DATE: 04.17.2018
TO: ProTrak
FROM: Mitesh Baxi
Traffic Engineering

■ **AAA CAR WASH SOUTH COLLEGE ROAD [TRC Plan Review #2]**

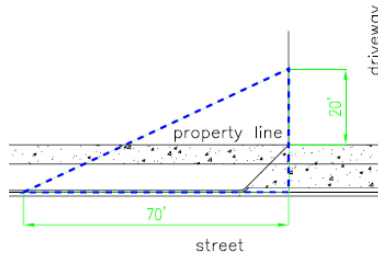
2. Sight distance triangle is not shown correctly on the site plan. Please show the City's 20'x70' sight distance triangle at the driveway as per below image [[Sec.18-529\(c\) \(3\) CofW LDC](#)].
